Origination Form
Proposed Revisions to a Standard Plans Index

Originator:	Meyer, Ronald	Index Number:	653-001
Date:	6/18/2025	Sheet Number(s):	1 of 1
E-mail:	Ronald.Meyer@dot.state.fl.us	Index Title:	PEDESTRIAN CONTROL SIGNAL INSTALLATION DETAILS

PEDESTRIAN CONTROL SIGNAL
INSTALLATION DETAILS

INDEX
653-001

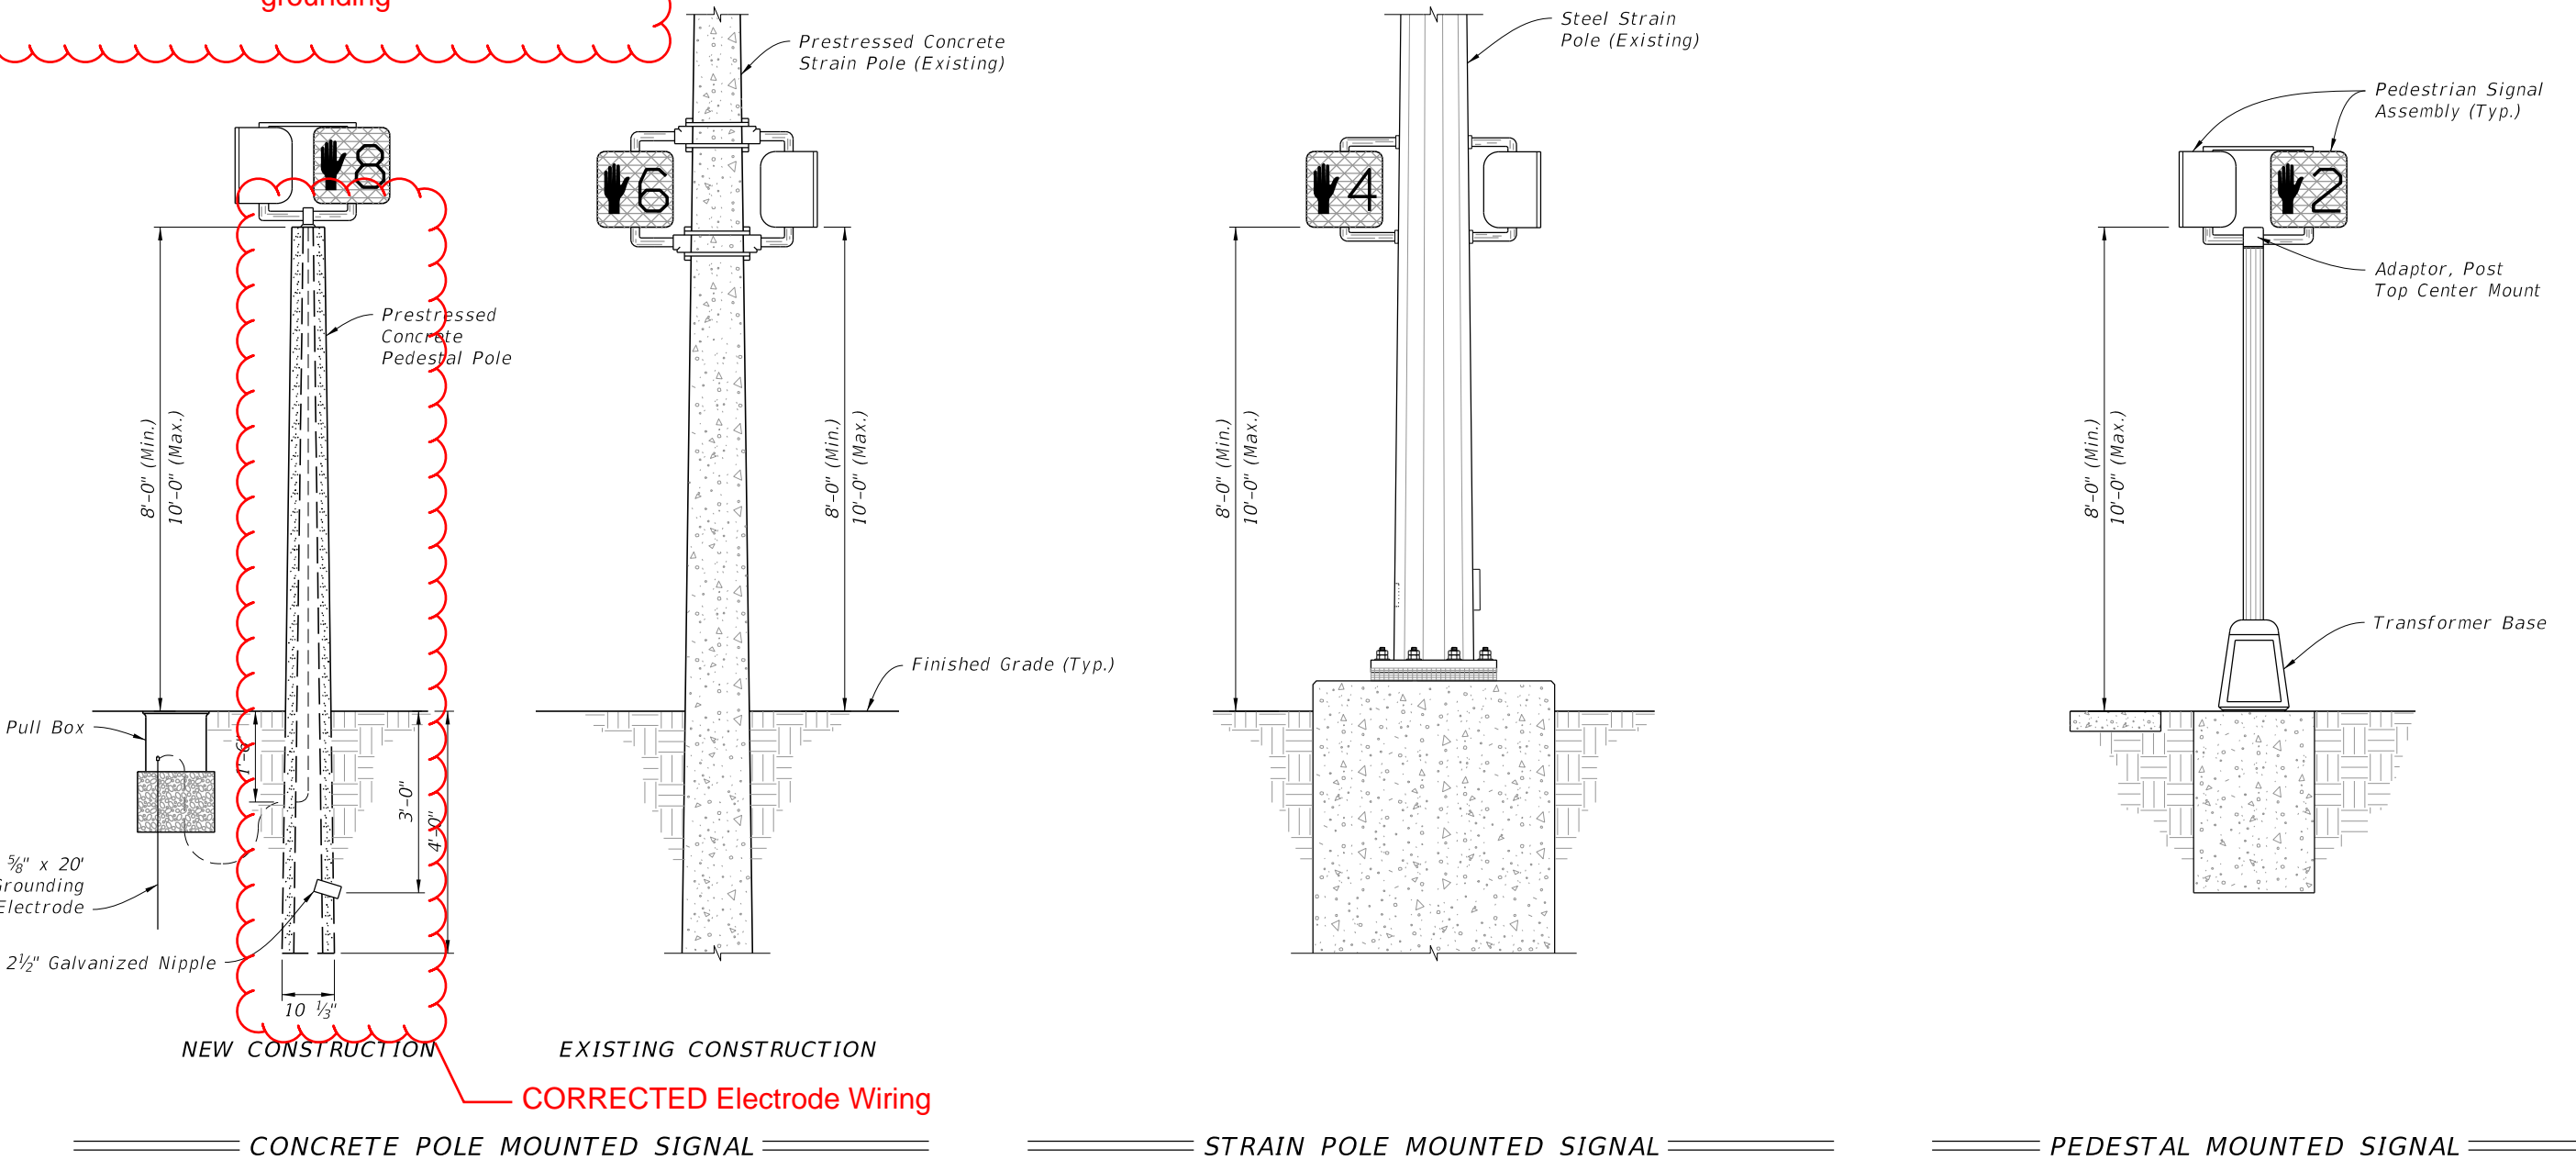
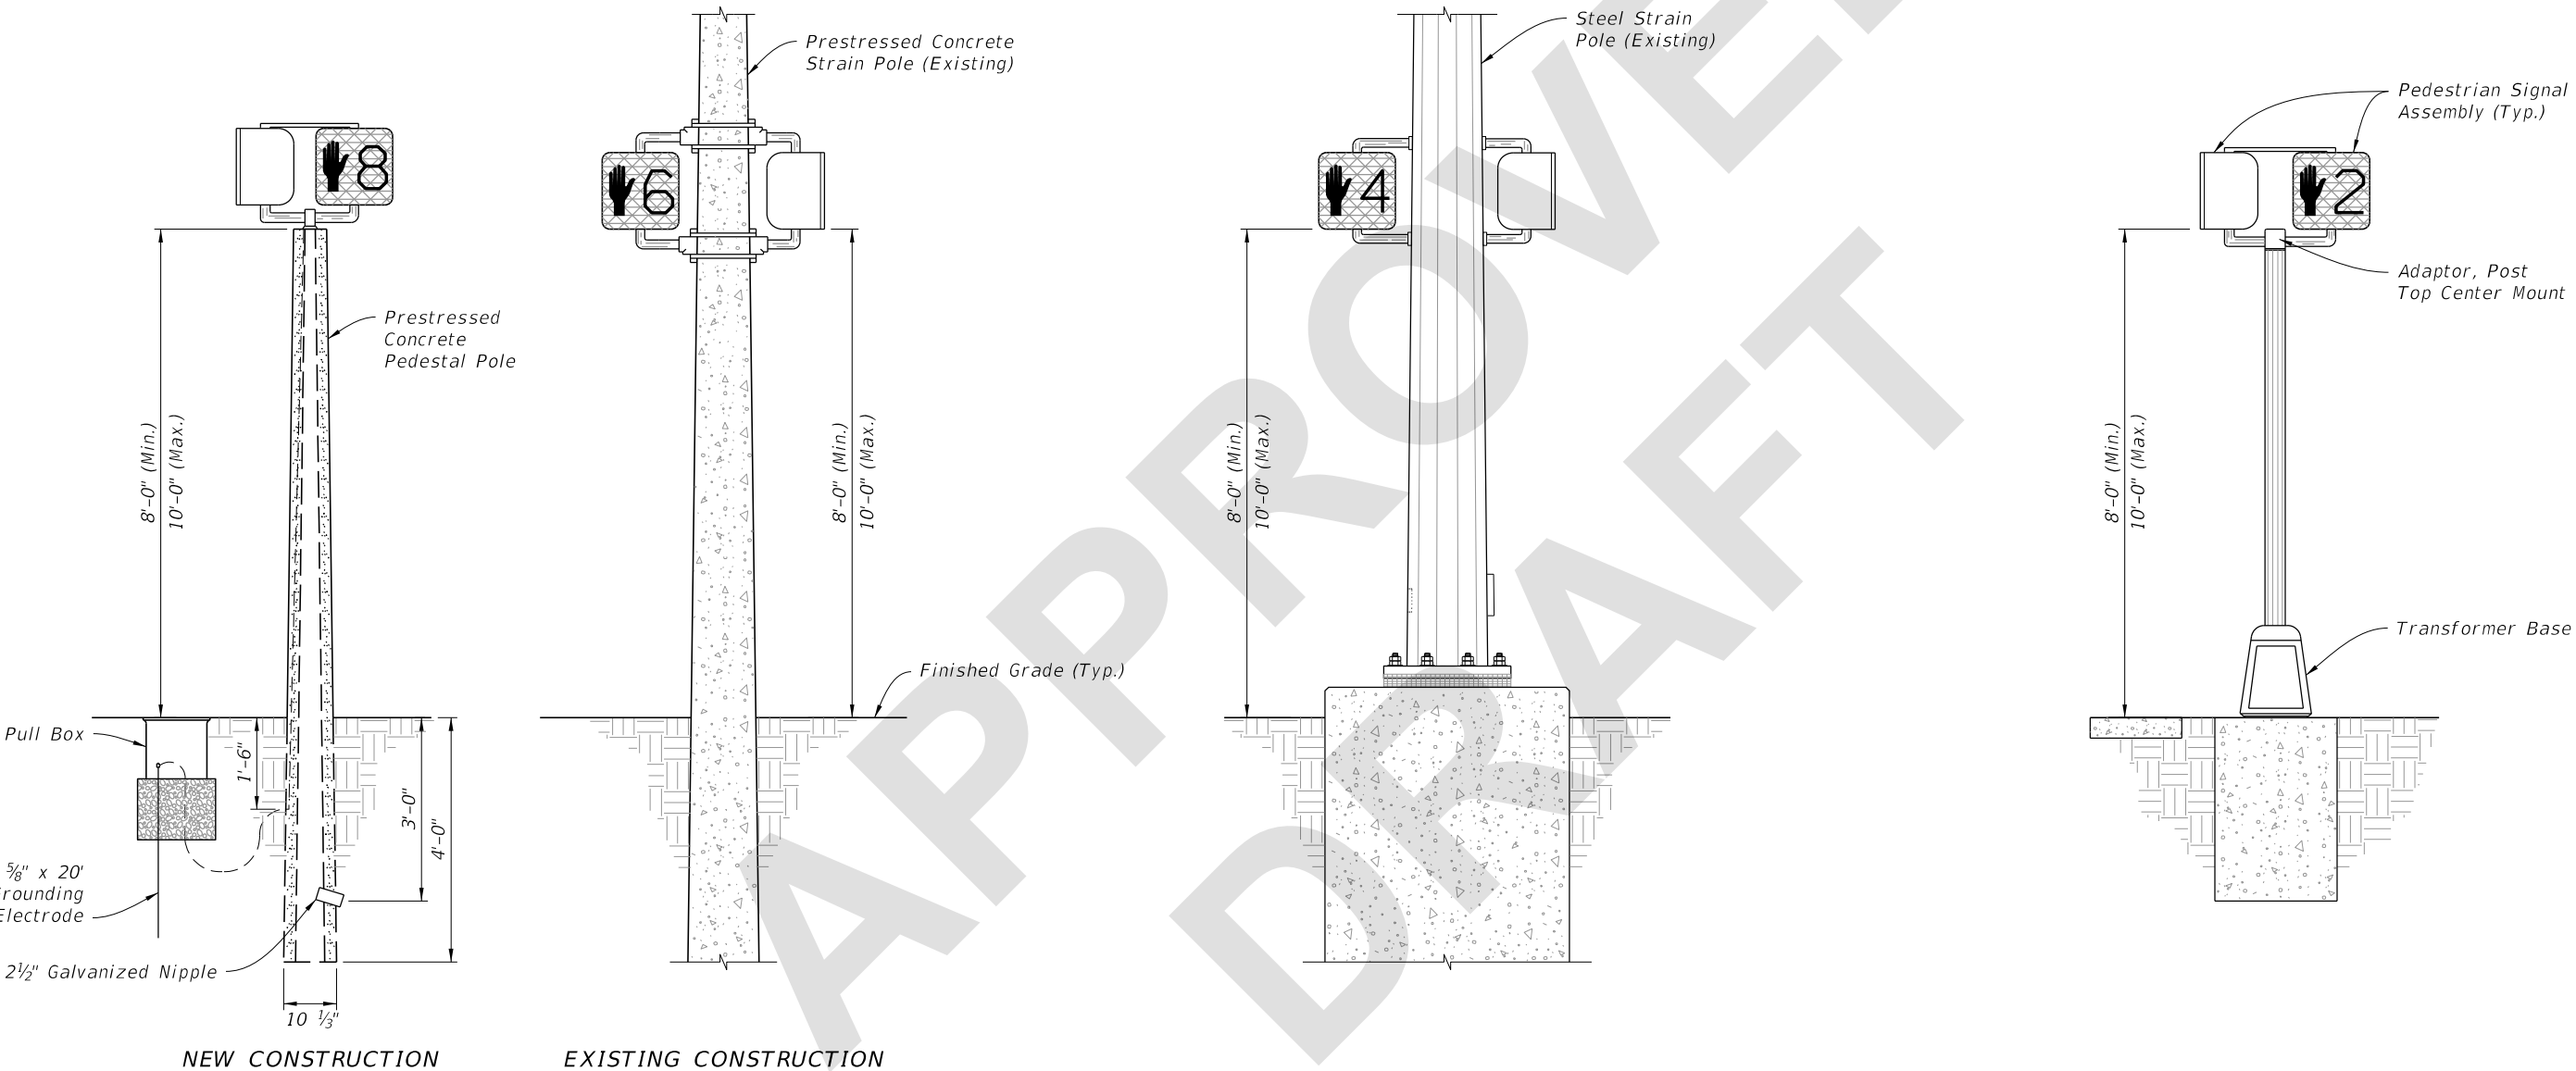
Sheet 1: Corrected wiring in Concrete Pole New Construction detail; Added "grounding" to Note 7

The TERL has received multiple questions from Contractors regarding clarification of grounding requirements for pedestal poles. This update is to help clarify requirements to reduce future questions. Corresponds with Specification update to 620-3.3.

posts, foundations, and grounding
